NOTICE OF INTENT TO DRILL

Sally 3420 1-12H

Summary of Changes

Correction Number: 2

COMANCHE County, Kansas
 200'FNL - 660'FWL Section 12 Township 34S Range 20W P.M.

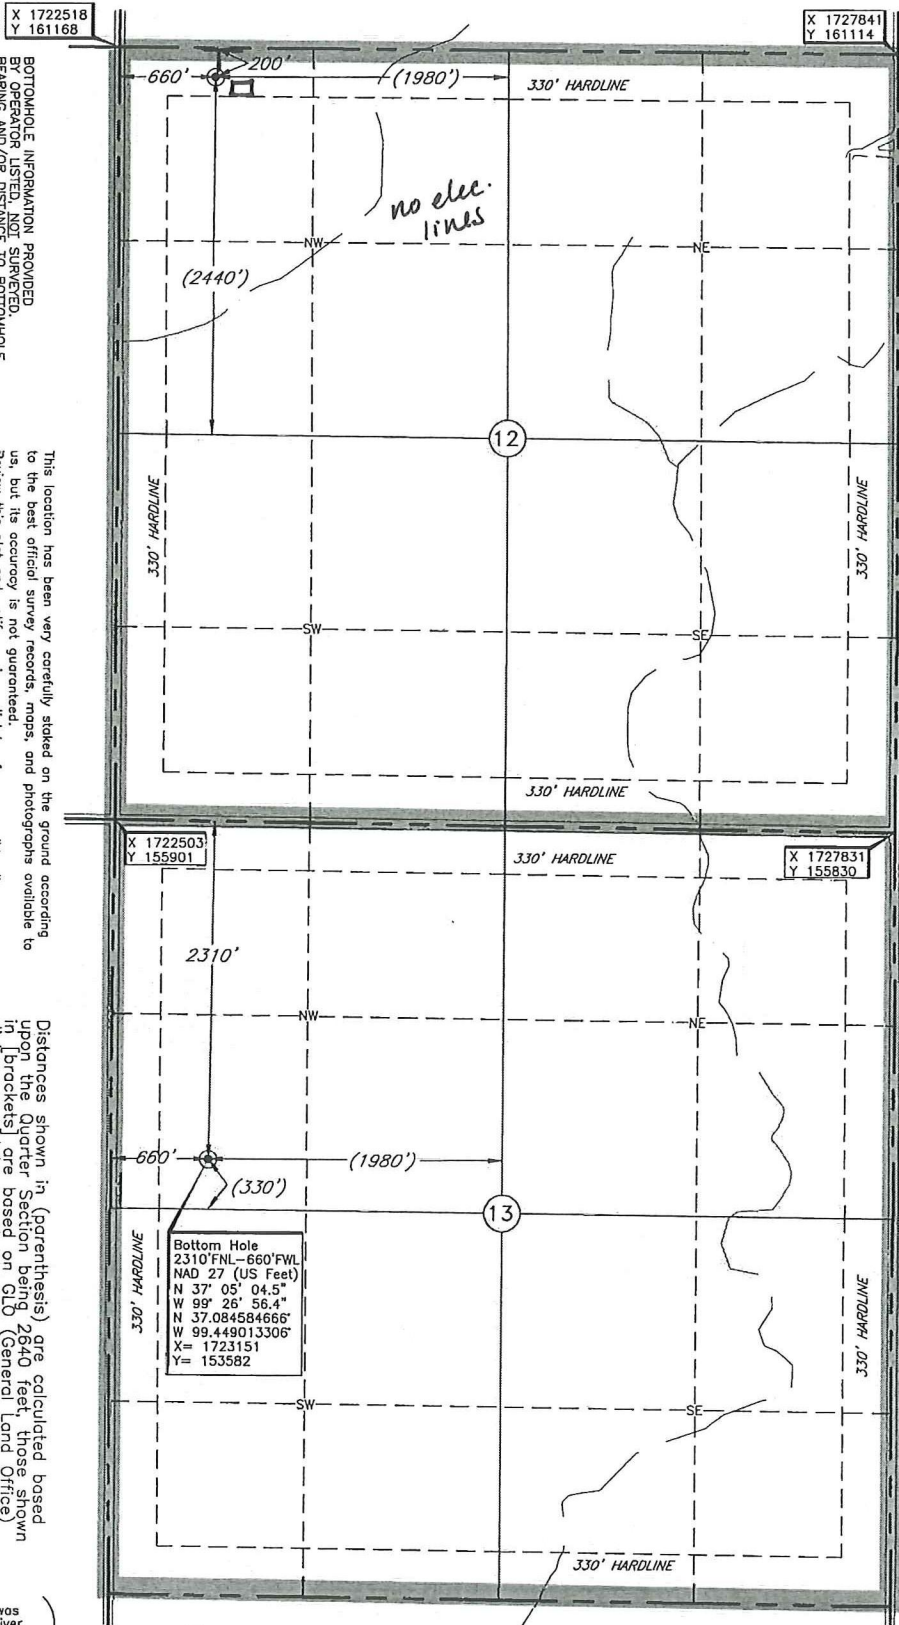
Please find attached an updated draft copy of Intent to Drill currently pending with the KCC for approval. The bottom hole location and surface pit dimensions have changed. We plan to drill the Sally 3420 1-12H well located in Comanche County, Kansas, and you are listed as current surface owner.

Field Name	Previous Value	New Value
Abandonment Procedure	Remove free fluid, let dry and backfill	Fold in liner and bury
Artificial Liner?	No	Yes
Bottom Hole Location	12-T34S-R20W 330' FSL & 660' FWL of the SW/4	13-T34S-R20W 2310' FNL & 660' FWL of the NW/4
Description of Pit Liner		20 mil plastic liner to be placed in pit and held with dirt around the
How Pit is Lined if Plastic Liner Not Used	Bentonite	
KCC Only - Approved By	Rick Hestermann 06/13/2012	Rick Hestermann 07/09/2012
KCC Only - Approved Date	06/13/2012	07/09/2012
KCC Only - Date Received	06/13/2012	07/09/2012
Liner Maintenance Procedures		Visually inspect liner periodically
Pit Capacity BBLs	1424	2225
